# **ENCLOSURE 1**

## **OVERVIEW OF BACKGROUND INVESTIGATIONS**

Potential Modification to Conceptual Layout

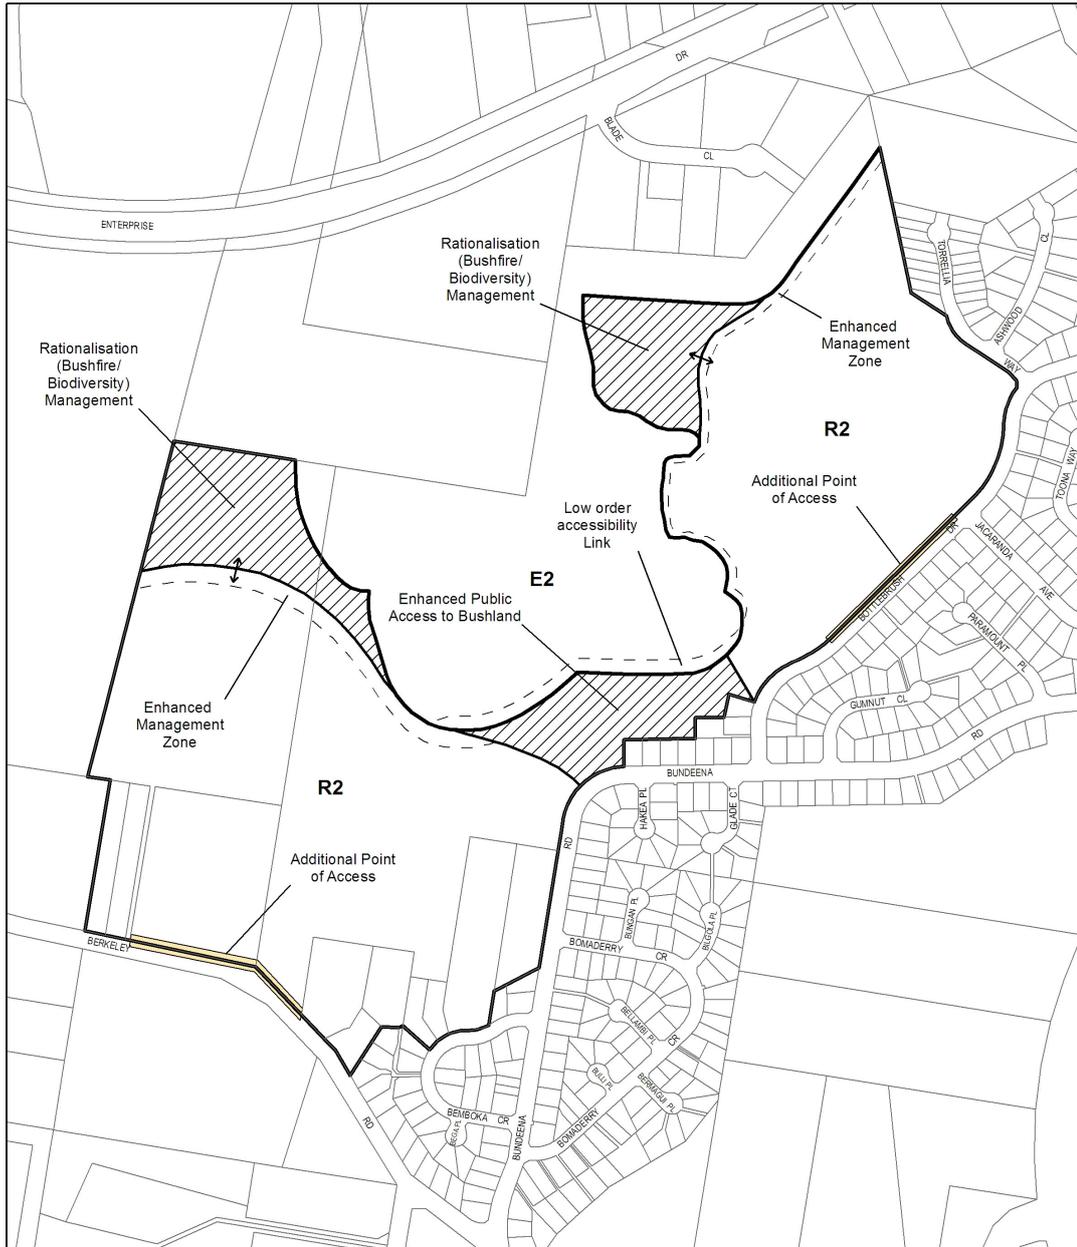
The “peninsula” style nature of the proposed residential extremities in the north west of each identified development precinct needs to be carefully reviewed.

The concept of a single public road connection from each development precinct to the surrounding public road network needs to be reviewed. Any review shall also have regard to traffic network impacts and amenity impacts upon existing residential development.

The two development precincts should be linked by a fire trail, as a minimum, it being noted that greater connectivity between the precincts is also required for enhanced urban design/accessibility outcomes. This, however, needs to be balanced with providing greater bushland connectivity with the broader community.

The development of an amended Masterplan shall ensure the integration of an appropriate vegetation buffer, including in particular the western and northern boundaries of Lot 511 DP205919, given the sensitivity of the adjoining land.
